SERVICE RECOMMENDATION

CEMENTING AND CHEMICAL SEAL RING
GROUTING SERVICE RECOMMENDATION
FOR

PARSONS BRINCKERHOFF / PB-KBB

EXPLORATORY SHAFTS:

PARSONS BRINCKERHOFF/PB-KBB
 RICH DOME SHAFT
 PRELIMINARY COMPLETION RECOMMENDATION

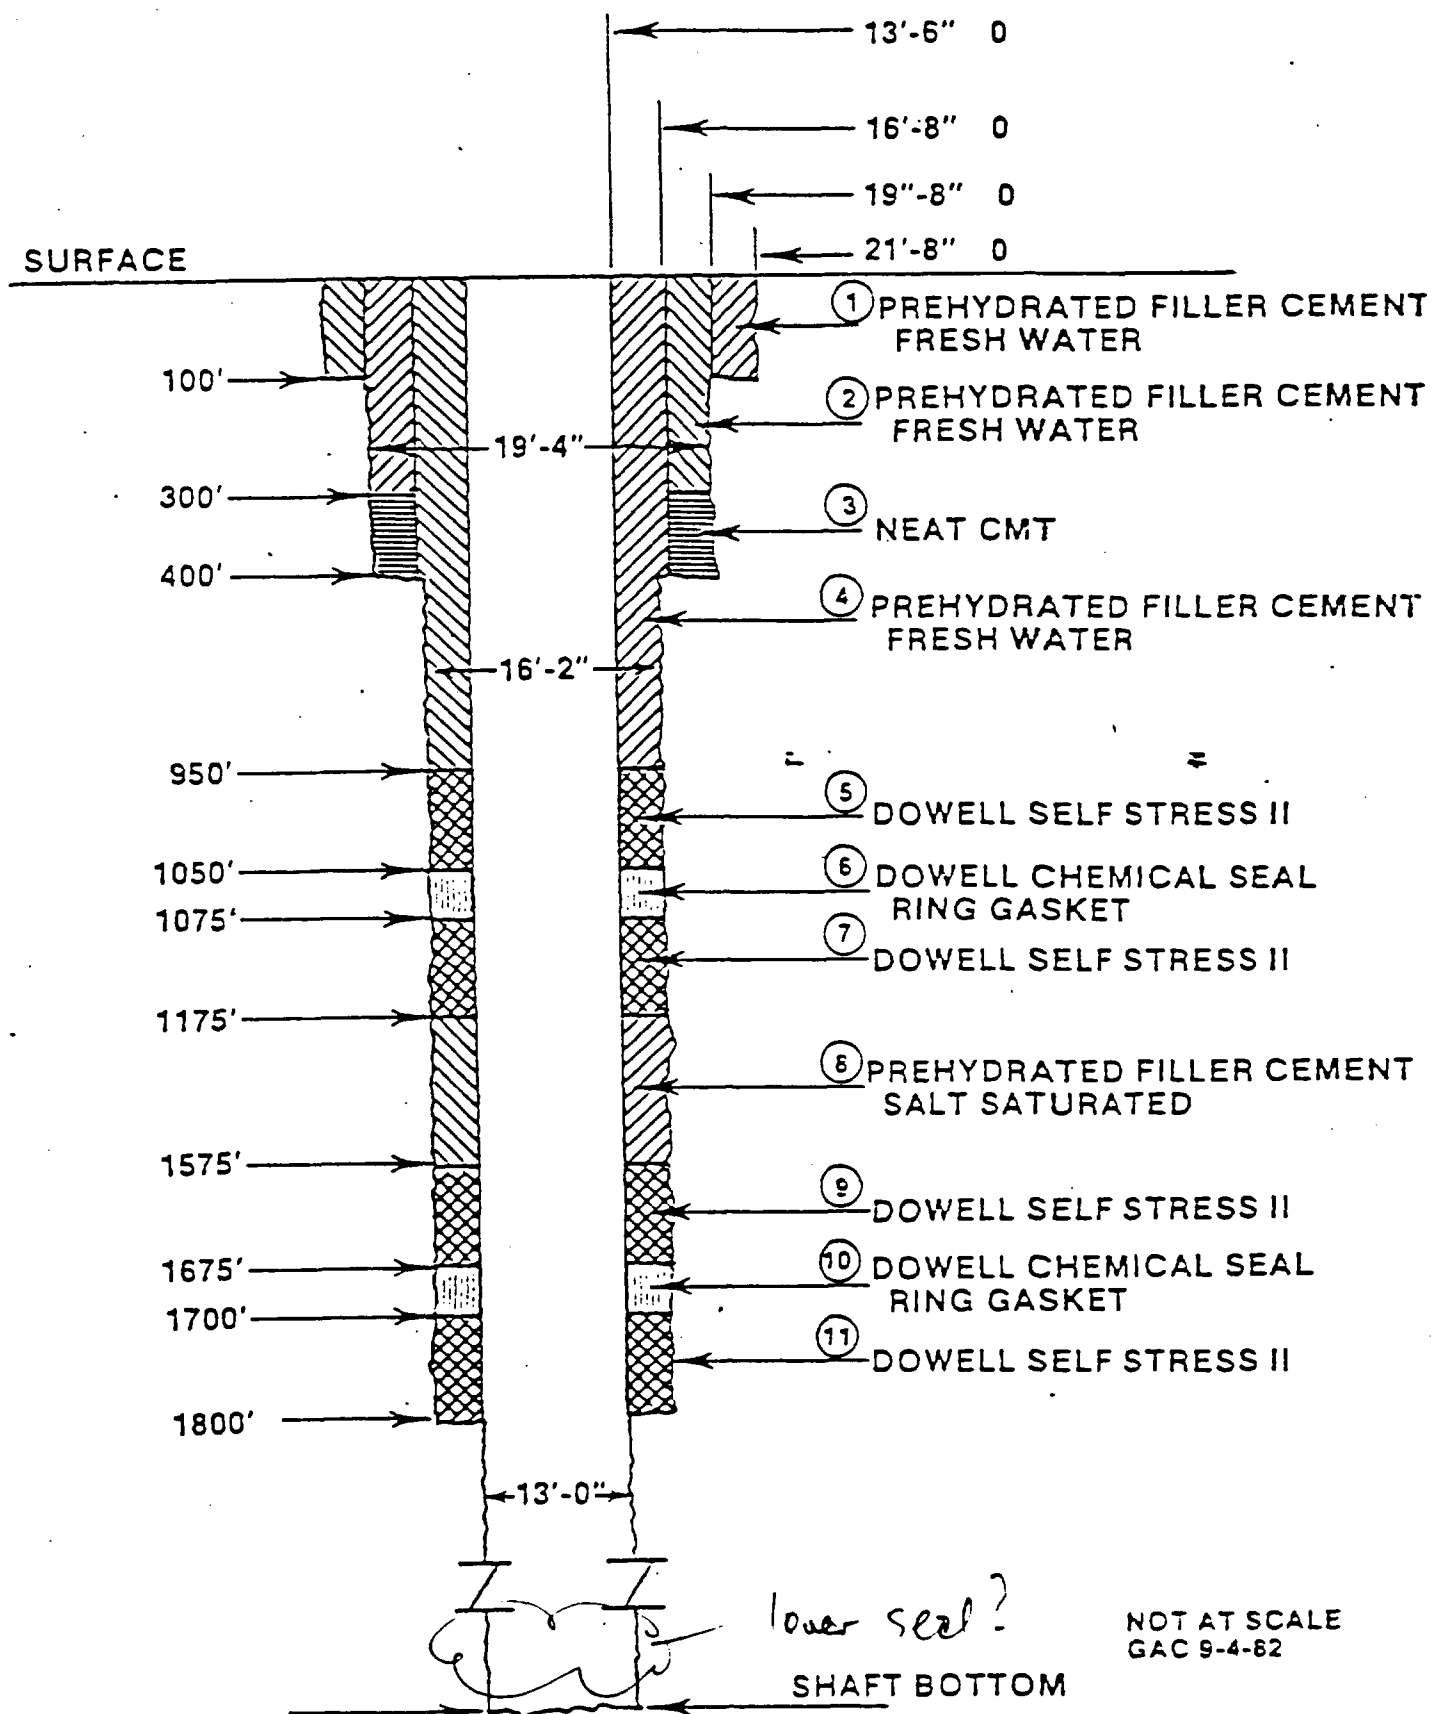
*What is the difference between
composition of Self Stress cement?*
